## NOVI PROFESSIONAL VILLAGE BUILDINGS D & E JSP20-17

Public Hearing at the request of Novi Medical Building, LLC for approval of the Preliminary Site Plan, Woodland Use Permit, and Stormwater Management Plan. The subject property contains 5.02 acres and is located in Section 27, on the west side of Novi Road, south of Ten Mile Road. The applicant is proposing to construct two 6,175 square feet professional office buildings, directly behind the three existing buildings on the property that were constructed in the 1991.

## PLANNING REVIEW

JOB 18002753  
SHEET NO. 02

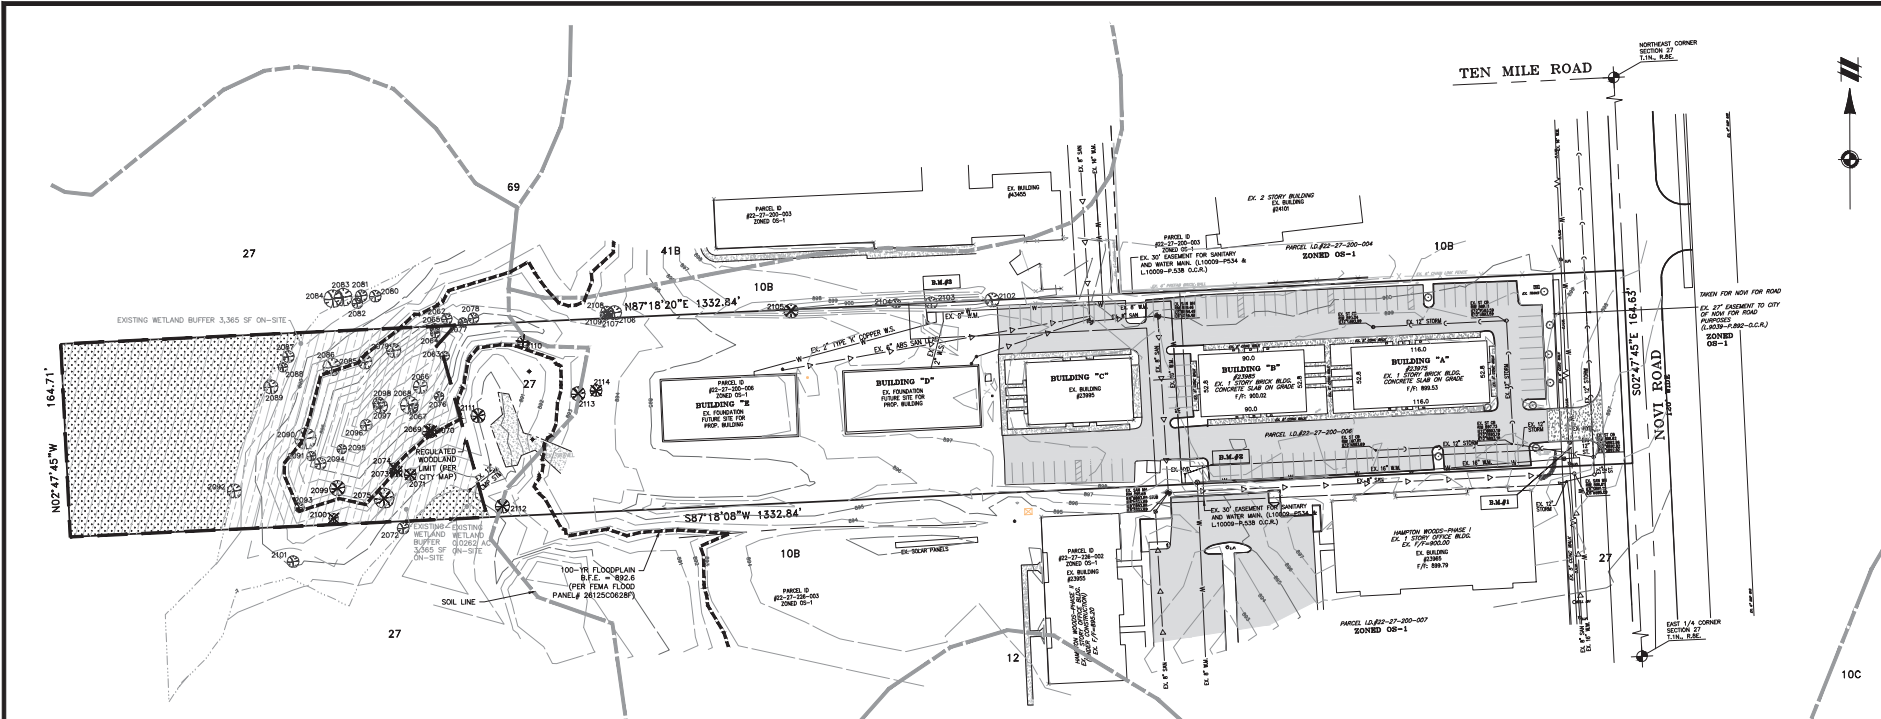
4. **Sheet 02. Existing Conditions.** The Tree List and Tree Replacement calculations are incorrect.

**Response:** *Tree list will be updated on the final plan, as requested.*
4. Sheet 02. Existing Conditions. The Tree List and Tree Replacement calculations are incorrect.

JOB 18002753  
SHEET NO. 04

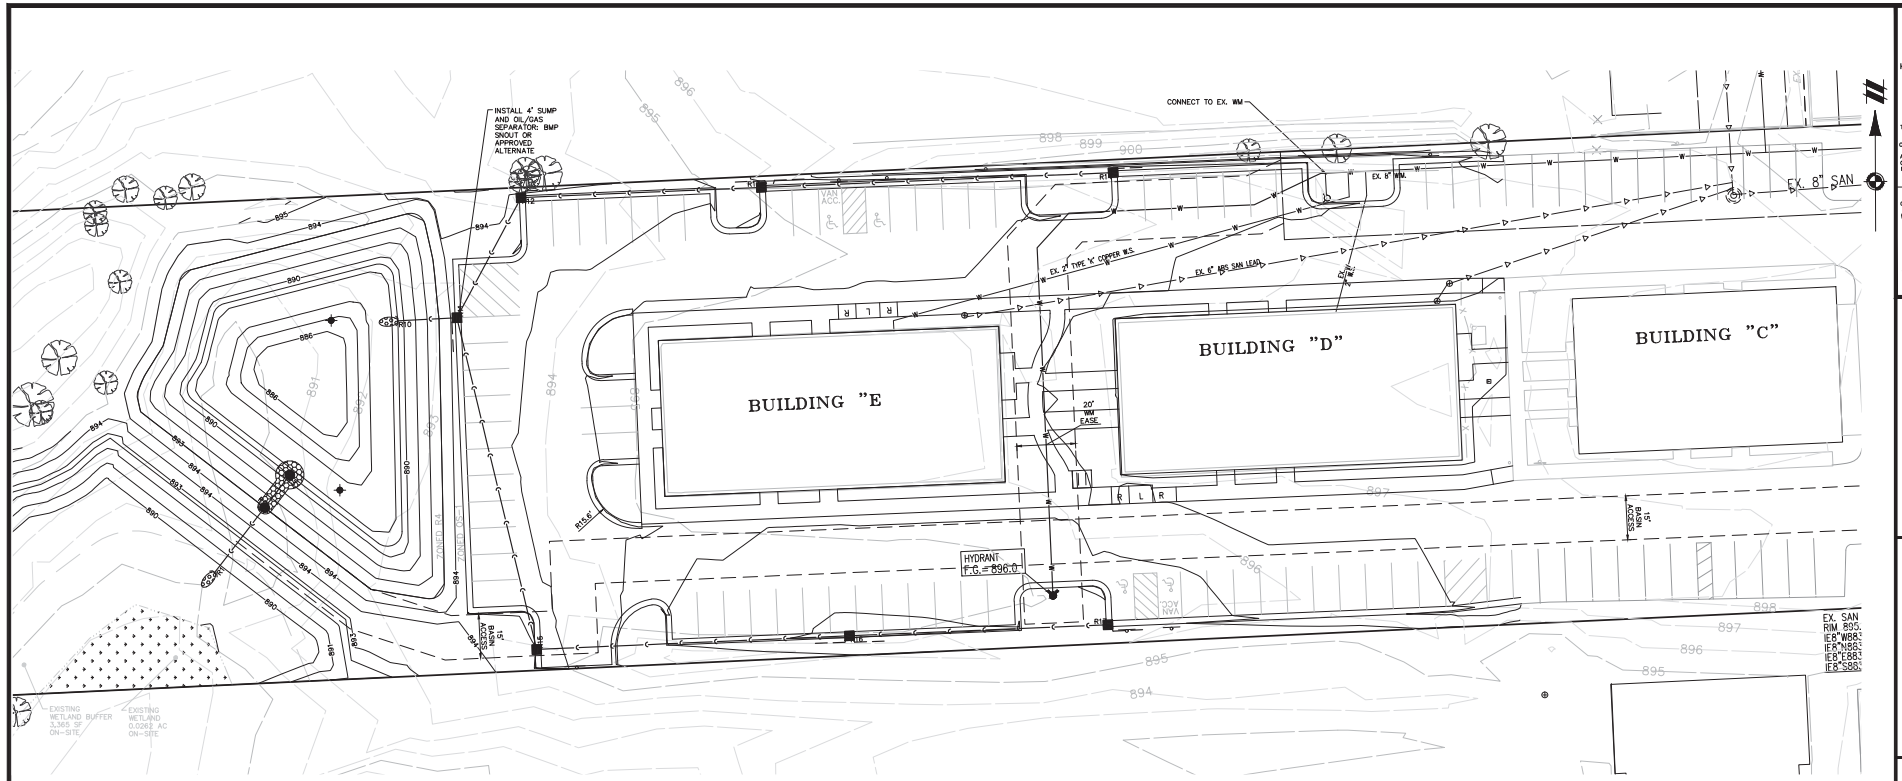
6. Specify MDOT Class II sand for the compacted sand backfill in Utility Note #3 on sheet 4, and illustrate and label on any utility profiles added to the plans.

12. Provide a profile for all proposed water main 8-inch and larger.
13. Label the pipe material, size, and length in the plan view, as well (noted in the Utility Notes on sheet 4).

17. Provide a sanitary sewer basis of design for the two proposed buildings on the utility plan sheet.
18. **Again, be aware the City of Novi Building Department may require verification that the existing sanitary leads to serve the proposed buildings are viable. This may include televising leads, exposing leads in-field, etc.**
19. Provide inverts and rim elevation for the existing leads and the manhole intaking the leads. Also, expand the viewport on sheet 4 to show the manhole.

19. Provide inverts and rim elevation for the existing leads and the manhole intaking the leads. Also, expand the viewport on sheet 4 to show the manhole.

**Response:** *The viewport on sheet 4 has been modified as requested. Existing lead inverts will be shown on the final site plan.*

SECTION 27  
TOWN 01 NORTH, RANGE 08 EAST  
CITY OF NOVI  
OAKLAND COUNTY, MICHIGAN  
NOV PROFESSIONAL BUILDING, LLC  
NOV PROFESSIONAL VILLAGE  
PRELIMINARY SITE PLAN  
GRADING AND SECC PLAN

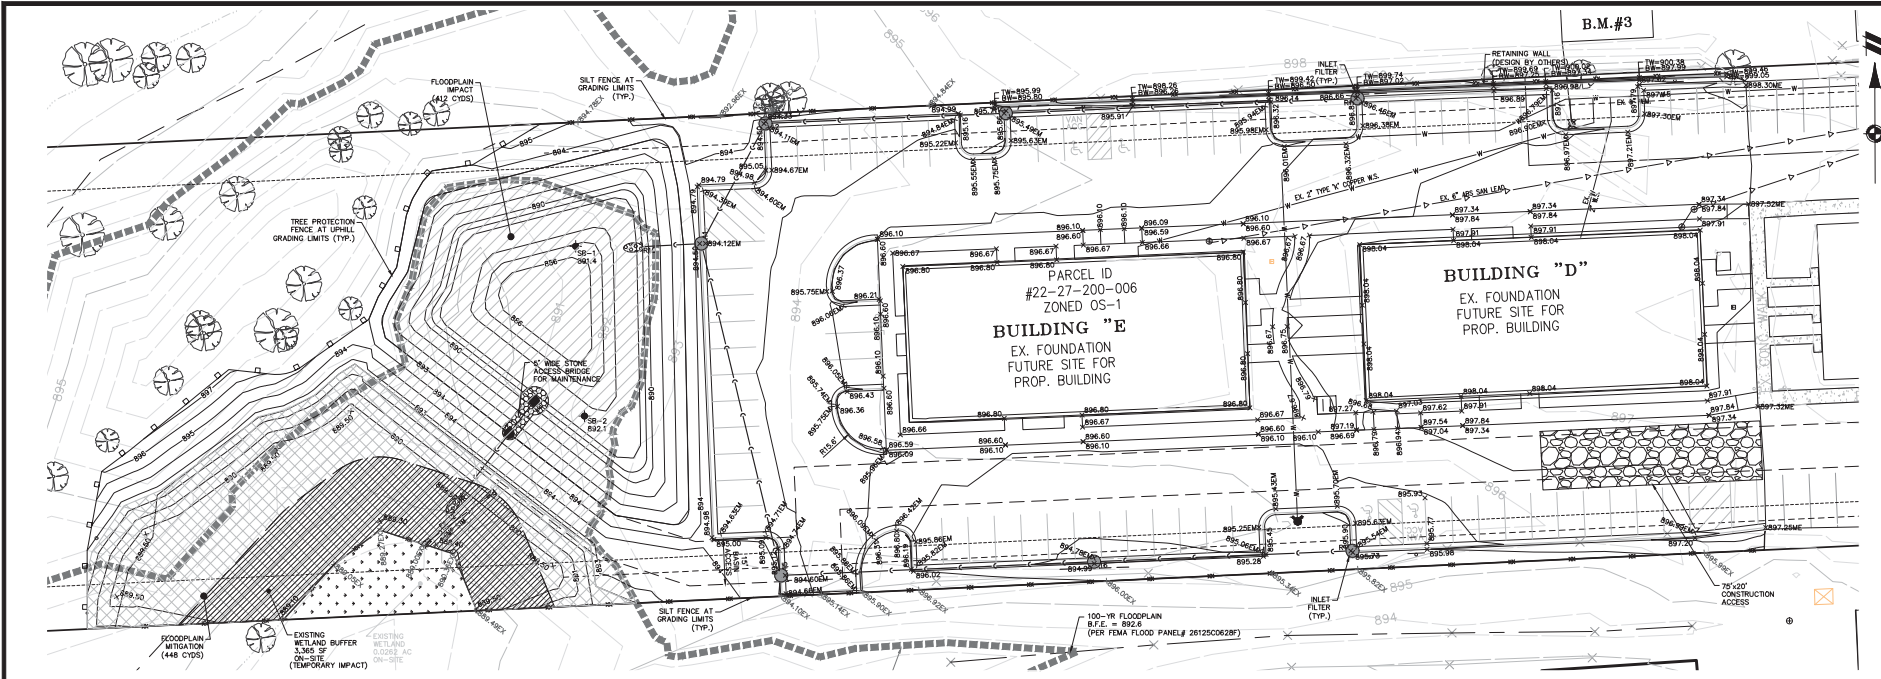
38. Clearly call out the on-site parking lot cross-section of 1.5 inches of MDOT 5E1 on 2.5 inches of MDOT 3C on 8 inches of 21AA [limestone only if within 100 feet of a watercourse] aggregate base.
39. Curb details are noted in the Grading Notes on sheet 5, but specify whether 18" or 24" wide curb proposed (appears to be 24").

39. Curb details are noted in the Grading Notes on sheet 5 but specify whether 18" or 24" wide curb proposed (appears to be 24").

**Response:** *The curb is currently proposed at 24". This has been added to the notes on sheet 5.*

JOB 18007253  
 SHEET NO. 07  
 NOT FOR CONSTRUCTION

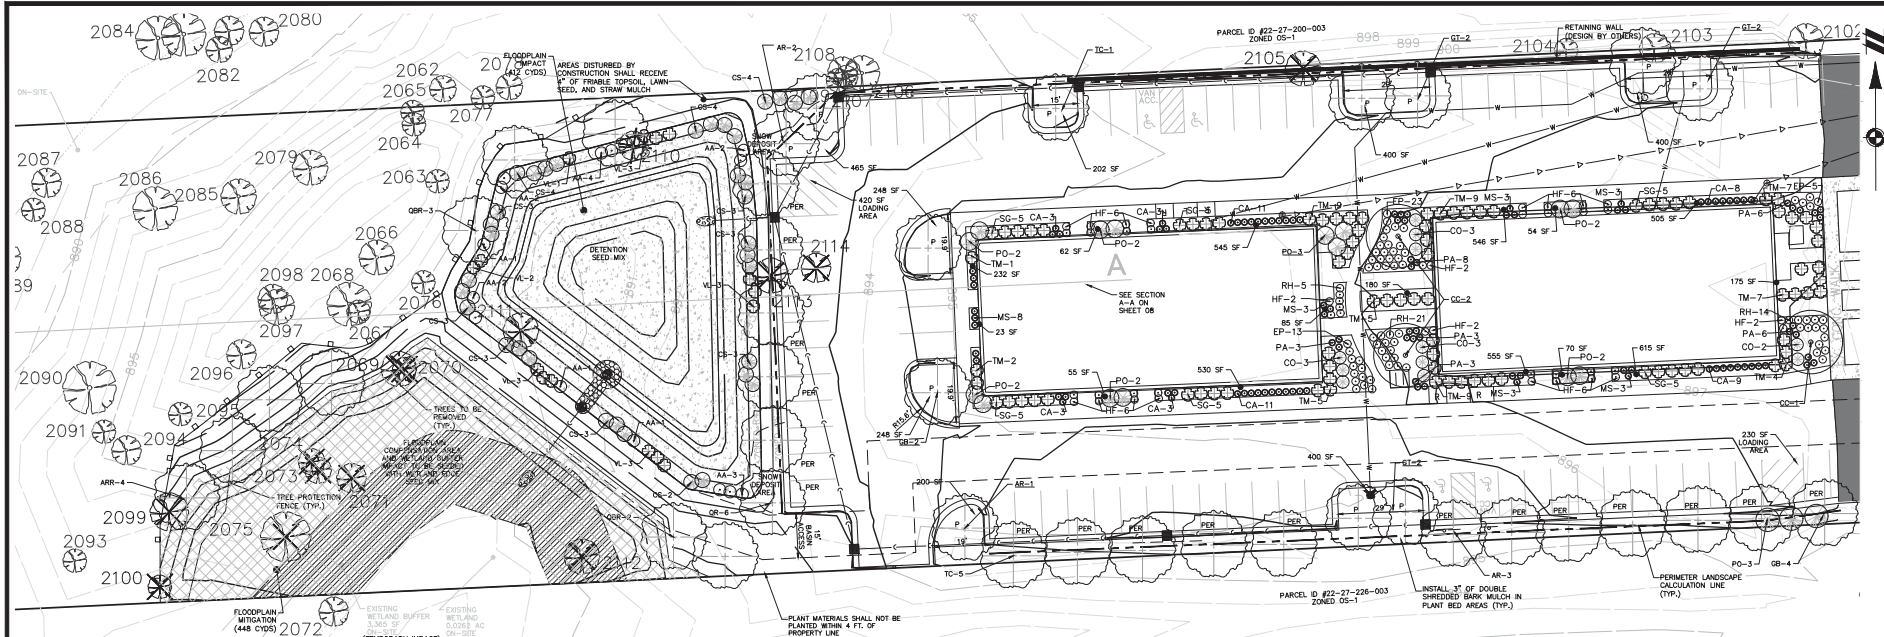
**Response:** *A ground cover note has been added to sheet 7. All areas are to be sod unless noted.*
13. Please change the striped island at the southeast corner to be a landscape island at least 200sf and plant a canopy tree in it to help meet interior parking lot tree requirement.

7. Please add the site address to the landscape plans.  
**Response:** *The site address has been added to sheet 7. The owners name and address are now shown on sheet 7.*

**Response:** *A note stating no power lines exist is shown on sheet 7 under "Landscape Requirement Notes".*

**Response:** *A note stating transformers will be screened when locations are known is shown on sheet 7 under "Landscape Requirement Notes".*

Figure 1. Novi Professional Village Site  
City of Novi Regulated Woodland Map

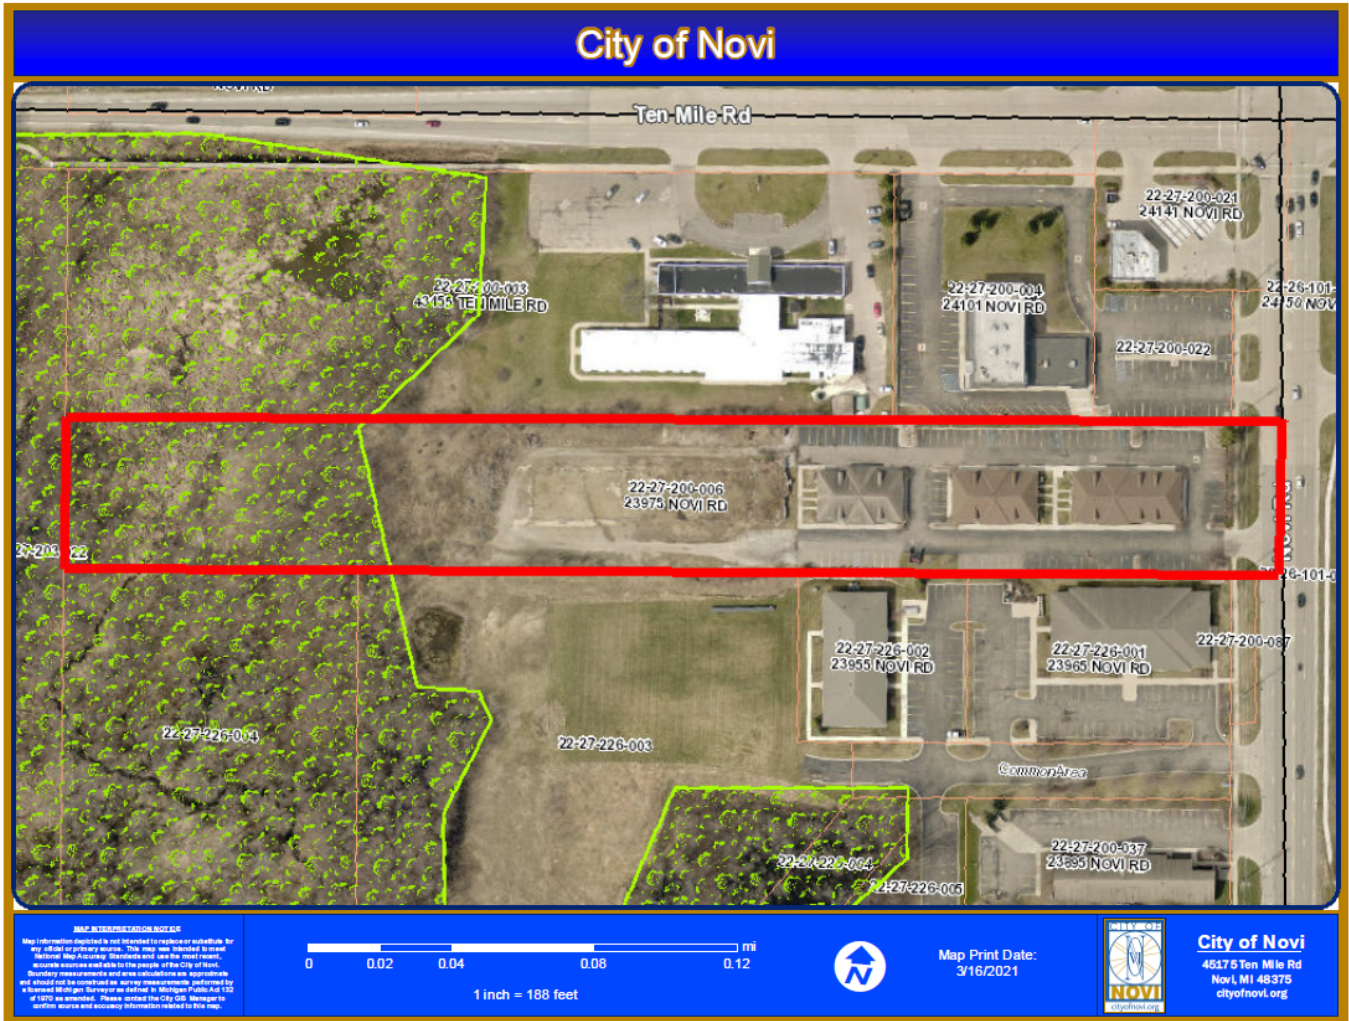
The applicant is proposing the construction of the final two (2) buildings, “D” & “E” and a stormwater detention basin at the Novi Professional Village development at 23975 Novi Road (Parcel ID: 50-22-27-200-006). The project site contains City-regulated woodlands (Figure 1).
